- **TMC236A-PA**
- **TMC236A-PA-T**
- **TMC236A-PA-X**

Product Change Notification

PCN-2016-06-03

Figure 1: TMC236 block diagram

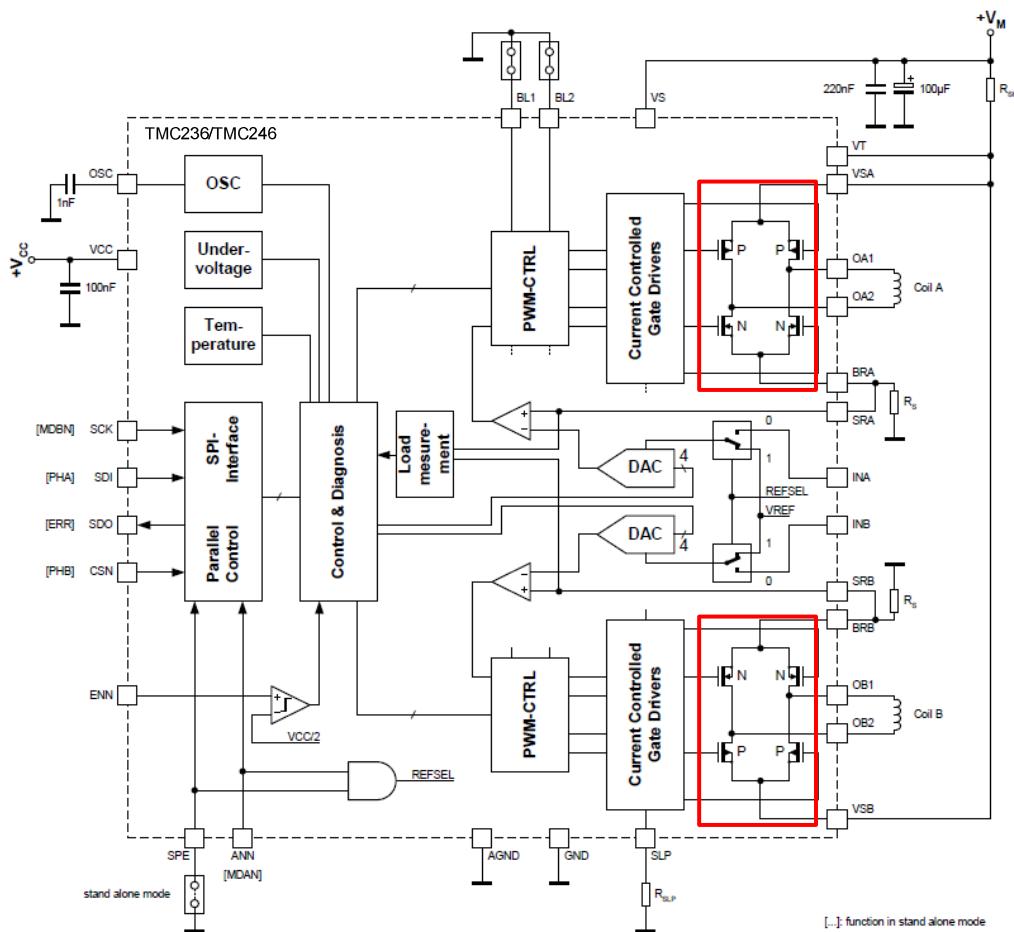
- Motor driver N-channel MOSFET (4pcs. in total)
- Motor driver P-channel MOSFET (4pcs. in total)
- Revision field of IC label will change from "A" to "B". (TMC236A to TMC236B)
- New motor driver MOSFETs will improve power losses due to lower R_{dson}

You can find the relevant MOSFETs (red marked) in the block diagram in figure 1. Due to the multi-chip structure of the TMC236 only motor driver MOSFET dies are affected to the changes. Complete digital and analog part of the core die as well as lead frame and IC structure stays unchanged.
